GILMORE – BELLETTY SUBDIVISION

APPLICATION NUMBER 3 DATE March 3, 2010
APPLICANT Gilmore - Belletty Subdivision
REQUEST Subdivision

DETAIL SITE PLAN

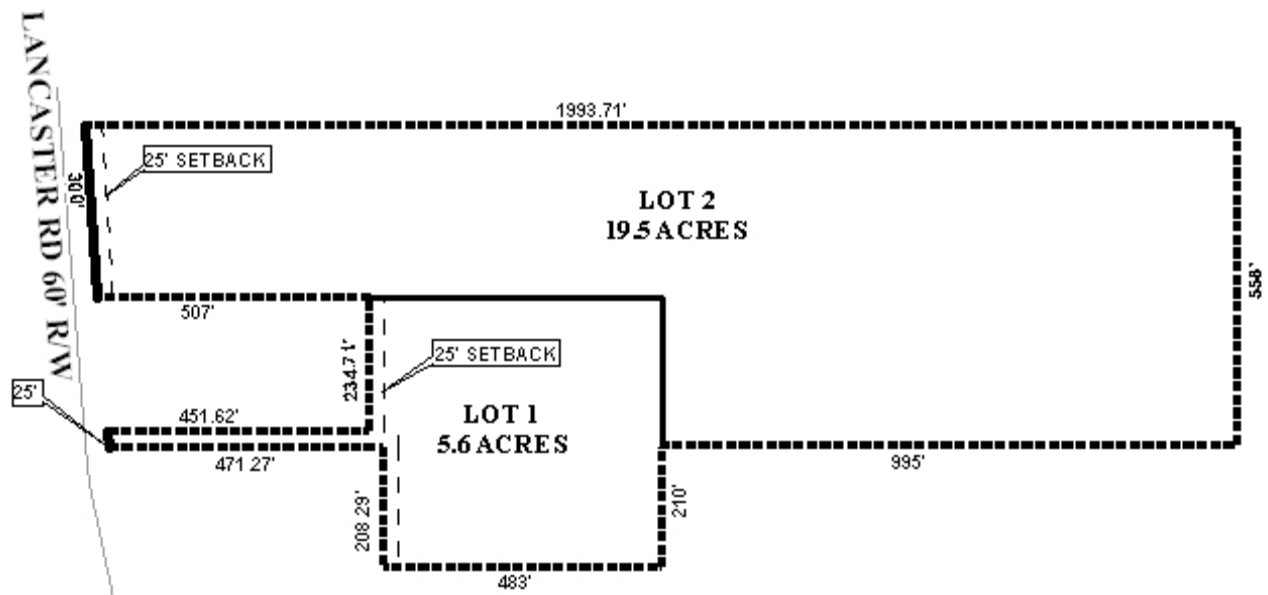
The applicant proposes that Lot 1 be a “flag” lot, with a 25 foot wide by 471.27'± foot long pole connecting the lot to Lancaster Road. There are currently two other “flag” lots in the area that were recorded when the area was outside the planning jurisdiction. On the recorded plats for the immediately surrounding lots, the 25 foot flag is depicted as part of the currently proposed Lot 1.

As proposed, Lot 1 will be 5.6± acres in size, with a pole of 25-feet in width. Future resubdivision of Lot 1 should be not be allowed until such time that additional frontage on a public street or compliant public/private street is provided.

It should also be noted that the proposed Lot 2 is 300'± wide at the building setback line and 1993.71'± deep. Section V.D.3. of the Subdivision Regulations states that the maximum depth of any lots, exclusive of unusable land shall not be more than 3.5 times the width at the building setback line. Using this calculation, proposed Lot 2 is 943.71'± deeper than allowed.

The 25-foot minimum building setback is shown and labeled on the preliminary plat, and should be retained on the Final Plat, if approved.

The lot sizes are labeled on the preliminary plat with the sizes in square feet and acres, and should be labeled on the Final Plat, if approved.

Based upon the preceding, the application is recommended for Tentative Approval with a waiver of Section V.D.3. of the Subdivision Regulations, subject to the following conditions:

- 1) depiction of the 25-foot minimum building setback line from all public right-of-ways, as required by Section V.D.9. of the Subdivision Regulations;

- 2) the labeling of each lot with its size in square feet, or placement of a table on the plat with the same information;
- 3) placement of a note on the Final Plat stating that any lots which are developed commercially and adjoin residentially developed property must provide a buffer, in compliance with Section V.A.8. of the Subdivision Regulations;

- 4) placement of a note on the Final Plat to comply with the City of Mobile storm water and flood control ordinances (*Must comply with the Mobile County Flood Damage Prevention Ordinance. Development shall be designed to comply with the storm water detention and drainage facility requirements of the City of Mobile storm water and flood control ordinances, and requiring submission of certification from a licensed engineer certifying that the design complies with the storm water detention and drainage facility requirements of the City of Mobile storm water and flood control ordinances prior to the issuance of any permits.*)

- 5) approval of all applicable federal, state and local agencies prior to the issuance of any permits or land disturbance activities;
- 6) placement of a note on the Final Plat limiting the lot to one curb cut to Lancaster Road, with the size, design, and location of all curb cuts to be approved by Mobile County Engineering and conform to AASHTO standards;

- 7) placement of a note on the Final Plat stating that approval of all applicable Federal, state and local agencies is required for endangered, threatened or otherwise protected species, if any, prior to the issuance of any permits or land disturbance activities; and
